CR018 GPII Inductor Rule Violation SOTE

CR018 GPII IND Rule Violation SOTE

GRDIST=Distance between coil and INDDMY

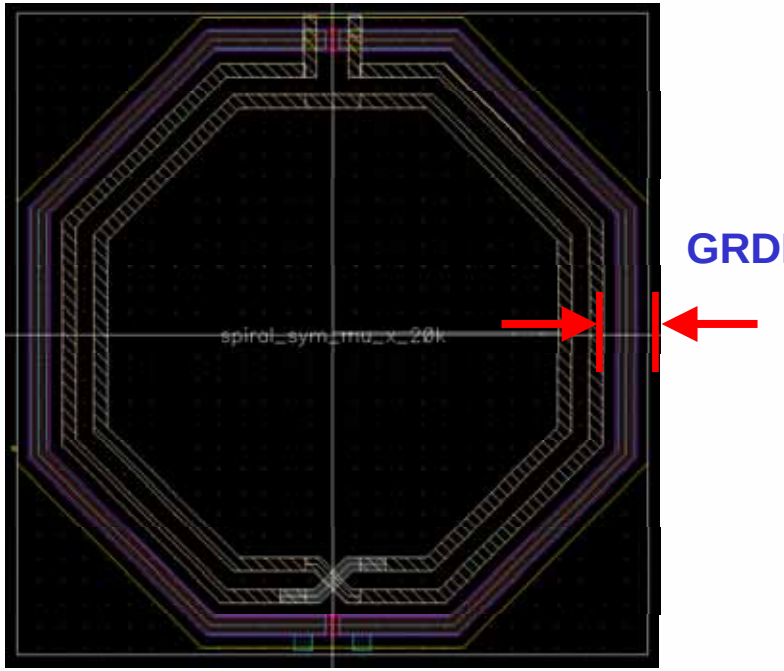
- **Customer may suffer the rule violation (UTM20K.E.3 & UTM40K.E.3) as using CR018 GPII Inductor PDK, due to TSMC had offered scalable guard-ring distance (10um~50um) for inductor of CR018 GPII. (T-018-LO-DR-001).**
- **Current rules definition:**

UTM20K.E.3	Minimum extension of dummy"layer "INDDMY" region beyond one UTM region which used as one inductor device.	G	≧	50
UTM40K.E.3	Minimum extension of dummy"layer "INDDMY" region beyond one UTM region which used as one inductor device. Recommendations: 1. Keep this enclosure as small and as close to 50 um as possible. 2. Keep INDDMY regions for separate inductors located as uniformly as possible over the whole chip area.	G	≧	50

- **TSMC will relax the rule and update DRM in 2010/Q2. "T-018-LO-DR-001"**
- **Please customer waive the rule violation caused by guard-ring distance as using CR018 GPII PDK, until DRM and new DRC deck update.**
- **The new rules update will be defined as following table: (It will be treated as recommendation rules).**

UTM20K.E.3U	Minimum extension of dummy"layer "INDDMY" region beyond one UTM region which used as one inductor device. Recommendations: Keep INDDMY regions for separate inductors located as uniformly as possible over the whole chip area.	G	≧	10
UTM40K.E.3U	Minimum extension of dummy"layer "INDDMY" region beyond one UTM region which used as one inductor device. Recommendations: Keep INDDMY regions for separate inductors located as uniformly as possible over the whole chip area.	G	≧	10
